主旨: Fw: S.16 Planning Application No. A/YL-KTN/1156 - Departmental Comments 附件: Responses to Departmental Comments EPD and FSD.docx; FSI 9.9.2025.pdf

Responses to Departmental Comments (A/YL-KTN/1156):

Vehicles, Vehicle Parts, Ancillary site office and toilet and Associated Filling of Land for the period of 3 years at Lots 629 S.O, 630 S.B ss.15 and 653 S.B RP(part) in D.D.110
Kam Tin, Yuen Long, New Territories

SCALE: N.T.S. @A1	DRAWN BY C.H.Liu	:
DATE: 05/09/2025	DESIGNED Ben Wong	BY:
DWG.NO: KT/OP/LP/01	CHECKED BY : Ben Wong	
CONTRACT NO.:		SHEET:

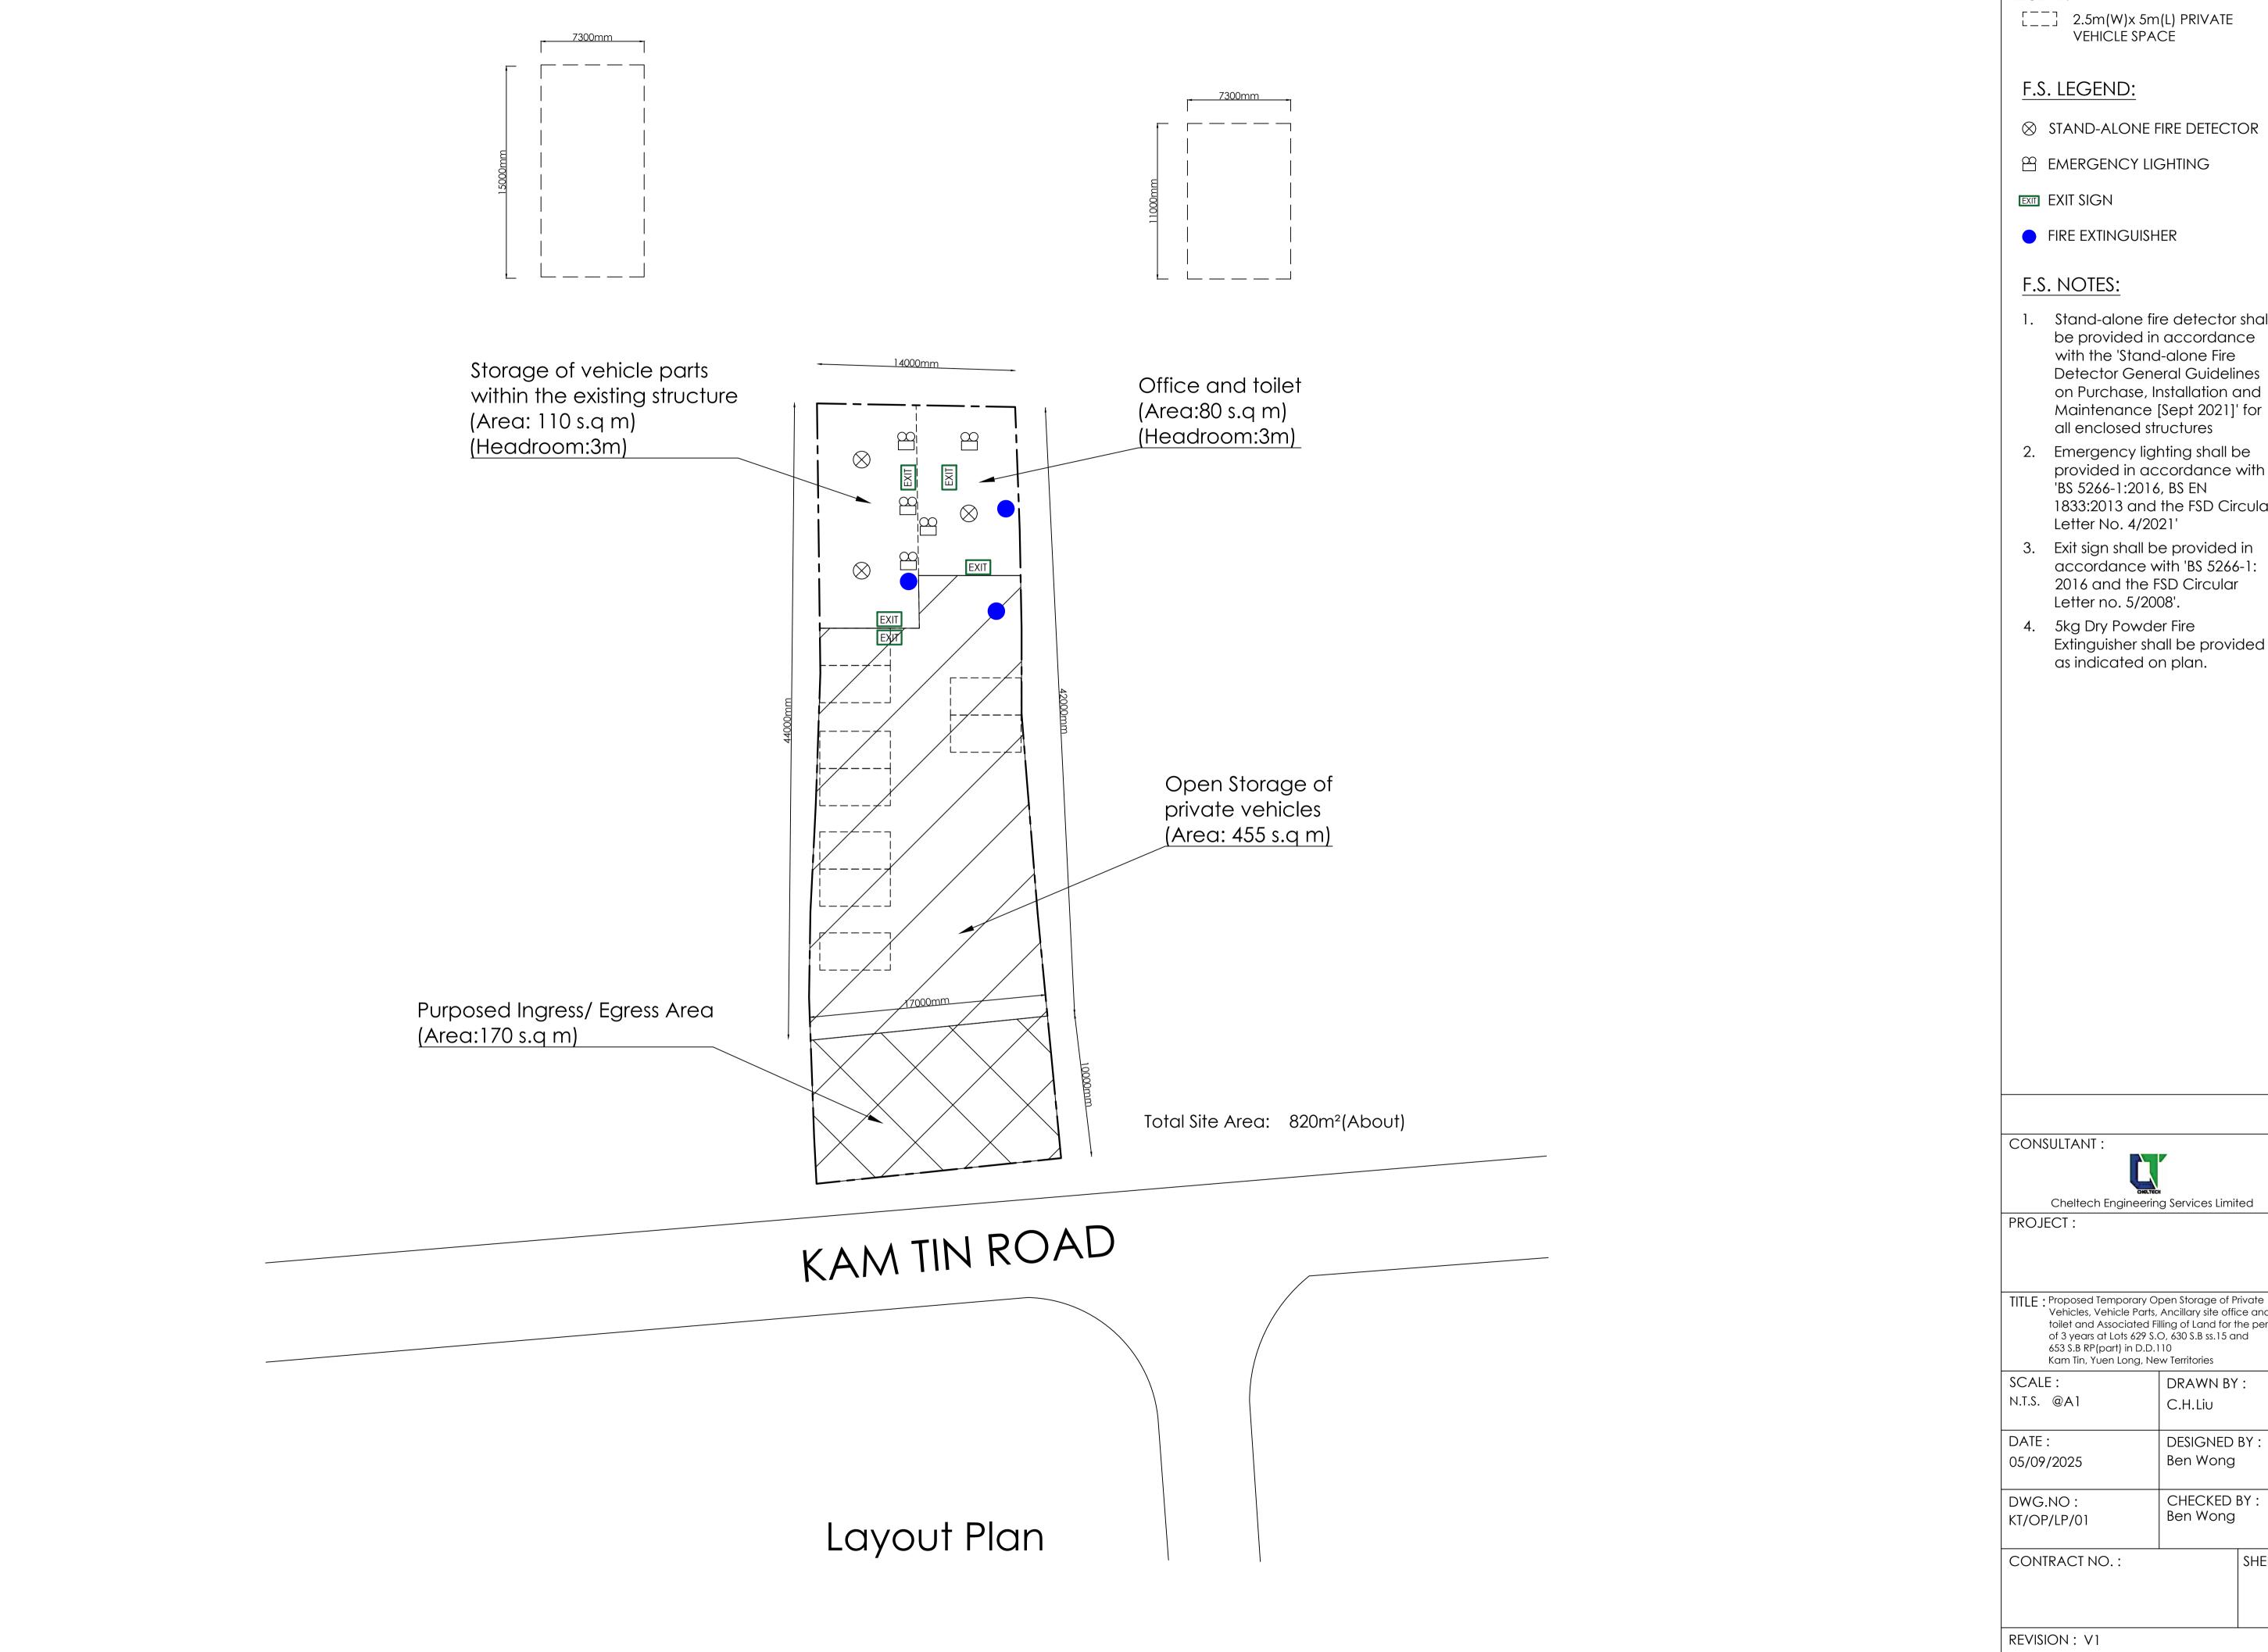
Department's Comments	Applicant's responses
Comments from Environmental	
Protection Department (Contact	
Person: Mr. Kelvin WONG; Tel.:	
2835 1117)	
Please advise what types of private	Used Saloon and SUV vehicles
vehicles will be stored at the site.	(Petroleum)
Comments from Fire Services	
Department Control Paragram Mr. CUEUNO	
(Contact Person: Mr. CHEUNG Wing-hei; Tel.: 2733 7737)	
Willig-fiel, Tel., 2733 7737)	
(i)Provision of FSIs shall be	Your comments stated in (i) to (ix) are
demonstrated in form of FS Notes with	noted. Please find our FSI as attached for
all relevant standards and	your further consideration. Thanks.
specifications;	
(ii) For enclosed structure with gross	
floor area not exceeding 230m2, only	
fire extinguisher and Stand-alone Fire	
Detector shall be provided;	
(iii) In relation to ii. above, where two	
or more Stand-alone Fire Detectors	
are installed in an enclosed structure, all stand-alone detectors shall be

interconnected (either wired or	
wirelessly) such that when one of the	
stand-alone fire detector is triggered,	
all connected Stand-alone Fire	
Detectors shall sound an alarm	
simultaneously;

- (iv) The Stand-alone Fire Detector shall be provided in accordance with the "Stand-alone Fire Detector General Guidelines on Purchase, Installation & Maintenance [Sep 2021]";

- (v) If the applicant self-initiates the provision of emergency lighting, the standards and specification shall be in accordance with "BS 5266-1:2016, BS EN 1838:2013 and the FSD Circular Letter No. 4/2021";

- (vi) If the applicant self-initiates the provision of directional and exit signs, the standards and specification shall be in accordance with "BS 5266-1:2016 and the FSD Circular Letter No. 5/2008":

- (vii) If the applicant self-initiates the provision of modified hose reel system, the standards and specification shall be in accordance with "Code of Practice for Minimum Fire Service Installations and Equipment 2022";

- (viii) If the applicant self-initiates the provision of fire alarm system, the standards and specification shall be in accordance with "BS 5839-1:2017 and the FSD Circular Letter No. 6/2021"; and

(ix) Modified hose reel system, fire
alarm system, emergency lighting,
directional and exit signs are
considered as self-upgrade and not a
mandatory requirement by this
Department.
